Re: **Insignificant Permit Modification**
Gibson Station RWS I Landfill, FP 26-06
Gibson Generating Station
Owensville, Indiana

Duke Energy Indiana, LLC (DEI) respectfully submits to the Indiana Department of Environmental Management the attached Insignificant Permit Modification for the Gibson South Landfill RWS Type I FP #26-06.

Re: Insignificant Permit Modification Request
Modification to Approved Landfill West Expansion Limits
Gibson Station South RWS I Landfill (RWS I Landfill)
SW Program ID 26-06
Gibson County, Owensville, Indiana 47665
Atlas Project No. 170DUK0034

FIGURE 3

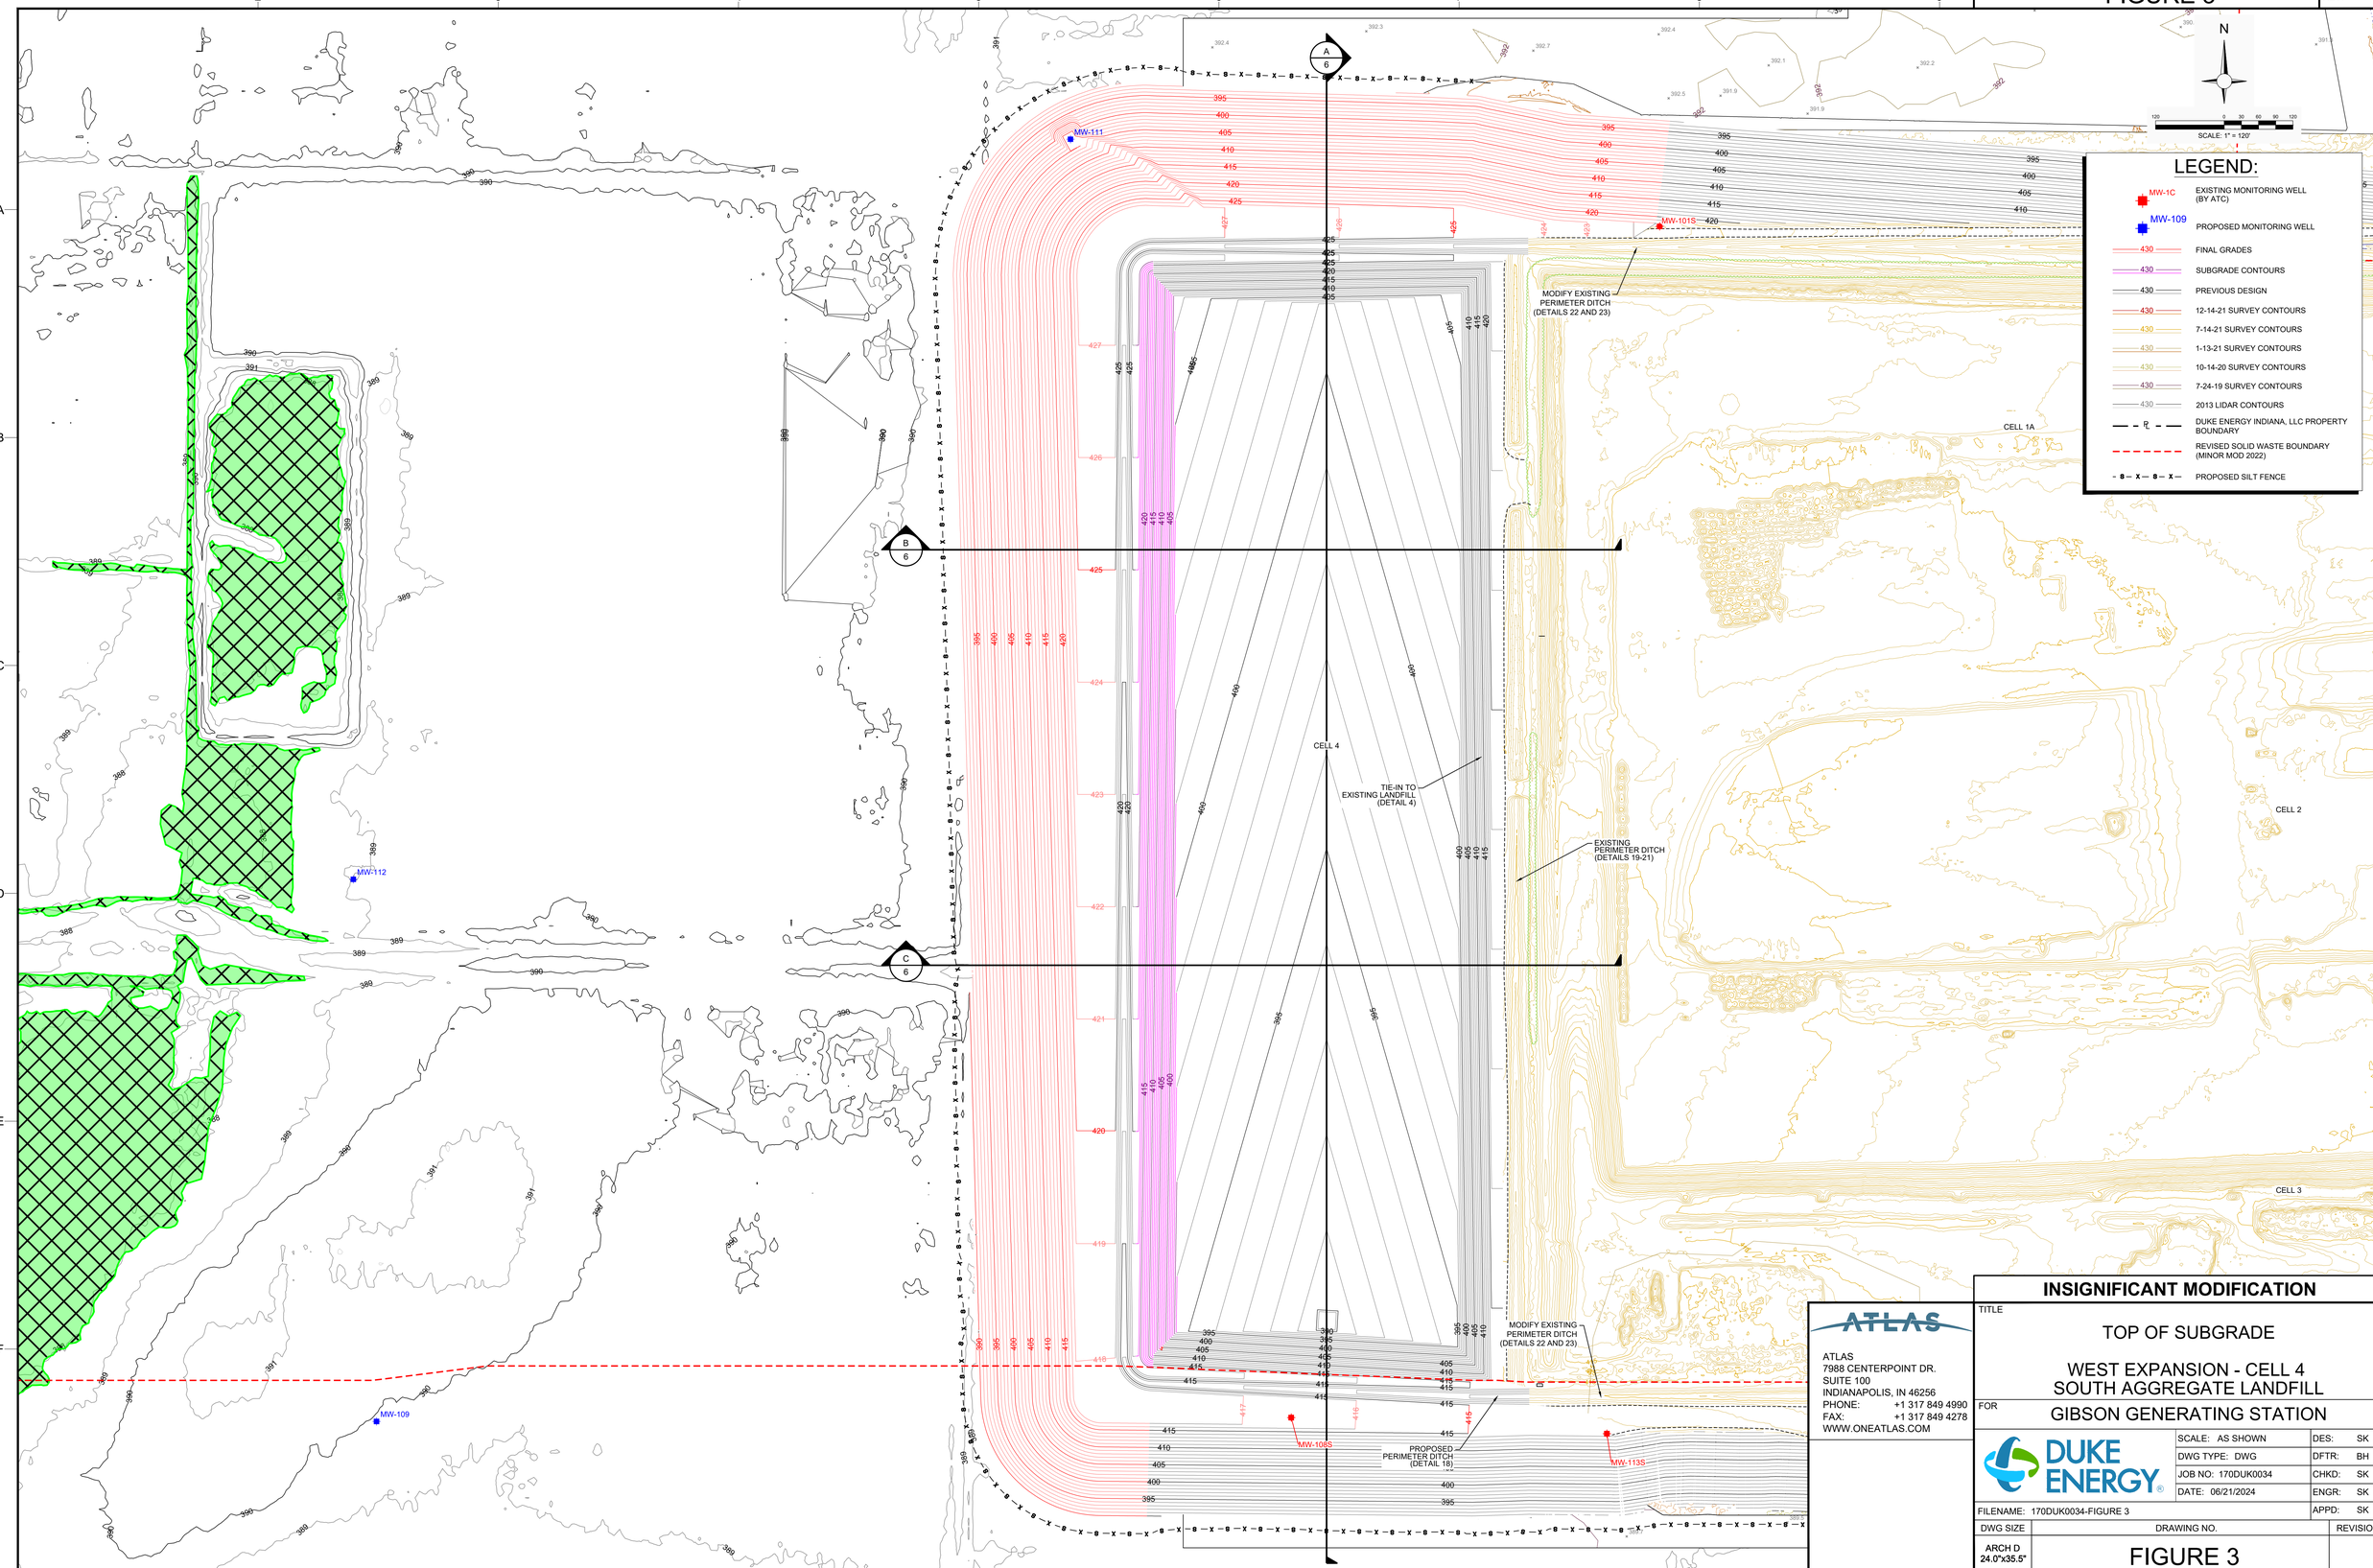
After receiving minor modification approval from IDEM, Duke Energy began planning for the construction of Cells 4 and 5 with a partial perimeter berm, as shown in Figure 2, with plans to construct Cell 6 at a future date. However, in the fall of 2023, Duke Energy updated the decommissioning plan for the Gibson Plant, resulting in a significant reduction in the projected CCR waste generation. At Duke Energy's request, Atlas reviewed the available airspace in Cells 1, 2, and 3 and re-evaluated the additional airspace required. Based on this evaluation, Atlas determined that constructing only Cell 4 will sufficiently accommodate the projected CCR waste from the Gibson Plant, making Cells 5 and 6 unnecessary in the near future. Figures 3, 4, 5, and 6, attached, depict the proposed modifications to the landfill expansion limits.

- Cells 5 and 6 will not be constructed at this time.
- A perimeter berm will be constructed around Cell 4.
- The leachate collection piping has been updated and is shown on Sheet 5.
- The width of the perimeter access road around Cell 4 has been modified from 12 feet to approximately 50 feet.

- There will be no changes to the exterior or interior slopes of the perimeter berm.
- There will be no changes to the Cell 4 baseliner grades and sump elevations.
